Service Bulletin

Bulletin No.: 24-NA-247

Subject: Information on Lower-Case Extension and Oil Pan Comparison

6756272

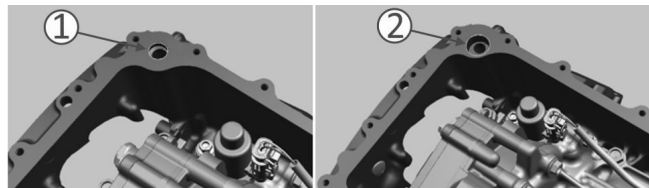
Locate the Part Unit Number (PUN) code on the side of the LCE for part validation.

If replacing the oil pan, verify the LCE oil flow check valve hole diameter.

- If hole diameter is 15.0mm (1) (LCE PN 12724347), repair with plastic oil pan (PN 12726914).
- If the hole diameter is 22.7mm (2) (LCE PN 12725073), install a check valve (PN 55501215) and aluminum oil pan (PN 12732388).

If the LCE is being replaced, service with PN 12725073, check valve, and aluminum oil pan.
